Rezoning Transportation Analysis
Petition Number: Insert Zoning Petition #2021-161
General Location Identifier: 22902119

Revision Log:	Date	Description
	08-20-2021	First Review (WB)

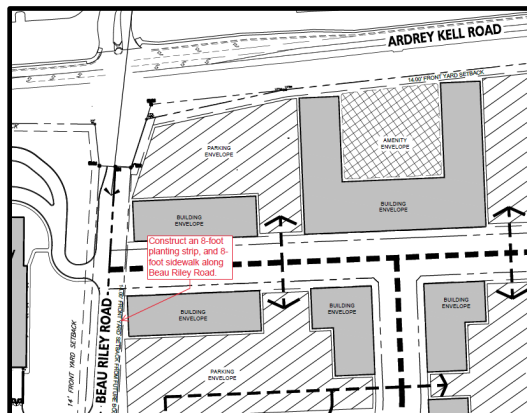
1. **Curbline:**

- a. **Ardrey Kell Road:** The existing curb and gutter is in its future location. No curb relocation required.
- b. **Beau Riley Road:** The existing curb and gutter is in its future location. No curb relocation required.

Label and dimension the curb and gutter from the centerline for each road on the site plan.

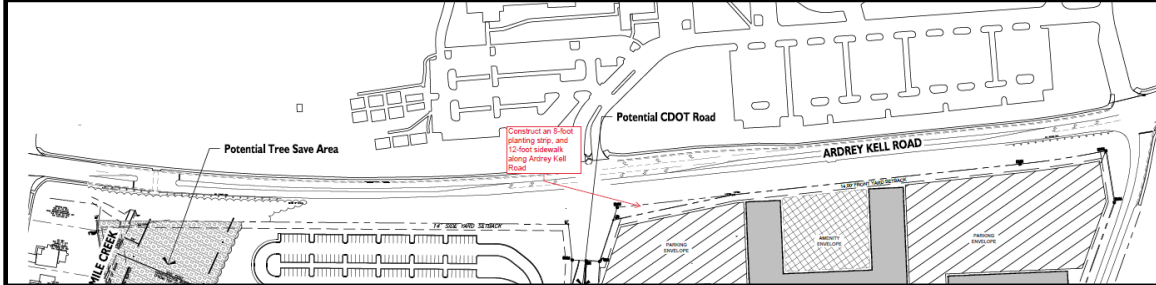
- 3. The proposed dwelling units exceeds 12 per acre. Per Chapter 20 Subdivision ordinance, site plan and conditional note(s) revisions are needed to commit to construct an 8-foot planting strip, and 8-foot sidewalk along Beau Riley Road. The wider sidewalk also meets the Charlotte WALKS Policy.

4. Site plan and conditional note(s) revisions are needed to commit to installing a 12' multi-use path with an 8' planting strip, along the site's Ardrey Kell Road Frontage to meet the Charlotte BIKES and Charlotte WALKS Policies.
